Access Compliance Report

Public Rights-of-Way

(Pedestrian Signals)

Intersection ID: N/A	Main Street:	Cross Street: N/A	Location: N/A
ADA ID: 0C412217490C	Signal Type: One Push Button-Non APS	Overall Compliance: No	Severity Score: BTN 1: N/A BTN 2: N/A No BTN: N/A
Codes/Mitigation Info/Possible Solution		Field Measurements/Component Compliance

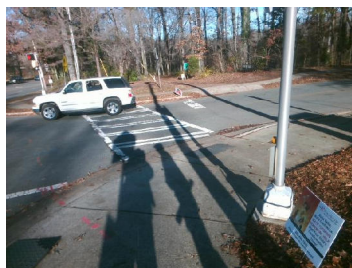
Compliance	Description	Data	Compliance	Description	Data
	Button Count	Button1	N/A	Distant to Additional Button (in)	N/A
	Additional Button Present?	No		Additional Button ID	N/A
N/A	Signal Buttons Required?	N/A	N/A	Additional Ped Posts Required	N/A
	How Many Ped Street Xings?	2		Located In An Island/Median?	No
N/A	B 1 Sign Present?	Yes	N/A	B 2 Sign Present?	N/A
Yes	B 1 Sign Purpose?	Yes	N/A	B 2 Sign Purpose?	N/A
Yes	B 1 Sign Lettering & Contrast?	Yes	N/A	B 2 Sign Lettering & Contrast?	N/A
Yes	B 1 Parallel To XWalk?	Yes	N/A	B 2 Parallel To XWalk?	N/A
Yes	B 1 PAR to Button?	Yes	N/A	B 2 PAR to Button?	N/A
Yes	B 1 PAR to XWalk?	Yes	N/A	B 2 PAR to XWalk?	N/A
Yes	B 1 Clear Floor Space?	Yes	N/A	B 2 Clear Floor Space?	N/A
N/A	B 1 FWD Approach?	Yes	N/A	B 2 FWD Approach?	N/A
N/A	B 1 FWD Approach Constrained?	No	N/A	B 2 FWD Approach Constrained?	N/A
No	B 1 FWD Approach Reach (in)	10.0	N/A	B 2 FWD Approach Reach (in)	N/A

N/A	B 1 FWD Approach Width (in)	N/A	N/A	B 2 FWD Approach Width (in)	N/A
N/A	B 1 FWD Approach Obstruction?	Yes	N/A	B 2 FWD Approach Obstruction?	N/A
N/A	B 1 FWD Approach Obstruction Dist (in)	1.0	N/A	B 2 FWD Approach ObstructionDist (in)	N/A
N/A	B 1 PARA Approach?	Yes	N/A	B 2 PARA Approach?	N/A
N/A	B 1 PARA Approach Constrained?	No	N/A	B 2 PARA Approach Constrained?	N/A
Yes	B 1 PARA Approach Reach (in)	9.0	N/A	B 2 PARA Approach Reach (in)	N/A
N/A	B 1 PARA Approach Width (in)	N/A	N/A	B 2 PARA Approach Width (in)	N/A
N/A	B 1 PARA Approach Obstruction?	Yes	N/A	B 2 PARA Approach Obstruction?	N/A
N/A	B 1 PARA Approach Obstruction Dist (in)	1.0	N/A	B 2 PARA Approach ObstructionDist (in)	N/A
No	B 1 Clear Floor Space Slope (%)	9.0	N/A	B 2 Clear Floor Space Slope (%)	N/A
No	B 1 Clear Floor Space XSlope (%)	5.9	N/A	B 2 Clear Floor Space XSlope (%)	N/A
N/A	B 1 PAR Slope (%)	5.6	N/A	B 2 PAR Slope (%)	N/A
Yes	B 1 Height (in)	40.5	N/A	B 2 Height (in)	N/A

Yes	B 1 Clear Xing Direction?	ClearlyMarked	N/A	B 2 Clear Xing Direction?	N/A
	B 1 Crossing Direction	To SW		B 2 Crossing Direction	N/A
Yes	B 1 DistanceTo XWalk (in)	0.0	N/A	B 2 DistanceTo XWalk (in)	N/A
No	B 1 DistanceTo Curb (in)	138.0	N/A	B 2 DistanceTo Curb (in)	N/A
Yes	B 1 Diameter (in)	2.0	N/A	B 2 Diameter (in)	N/A

Possible Solutions: Replace Signal Push Button With APS Button on New Post. Remove & Relocate Sign.

PROW/ADA: TMUTCD 4e.08, R404.2, R404.3, R406.2
